# UNITED STATES PATENT AND TRADEMARK OFFICE

APPLICATION NO.	FILING DATE	FIRST NAMED INVENTOR	ATTORNEY DOCKET NO.	CONFIRMATION NO.
09/988,891	11/19/2001	Leslie L. Deck	09712-099001 / Z-204	9186

## Office Action Summary

## DETAILED ACTION

FIGURE 1

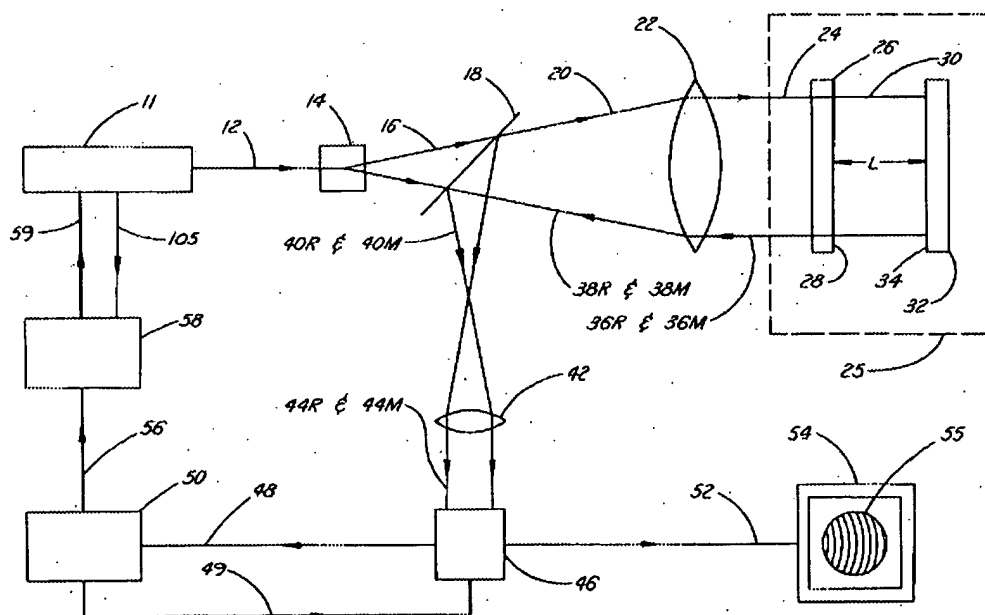
Claims 1-5, 8, 9, and 17-24 are rejected under 35 U.S.C. § 102(b) as being clearly anticipated by Sommargren(4,594,003).

Sommargren teaches a tunable laser source(11), an unequal path interferometer(25), detector array(46), and a system controller(50). With regard to the system controller of claims 1-5, 8, and 20-24; the limitations that the system controller is programmed to perform various functions does not provide a limitation in any patentable sense. The limitations are functional and as the claims do not invoke 35 U.S.C. 112, 4th paragraph by using a means-plus-function format the functional limitations do not further limit the claimed invention. See figure 1.
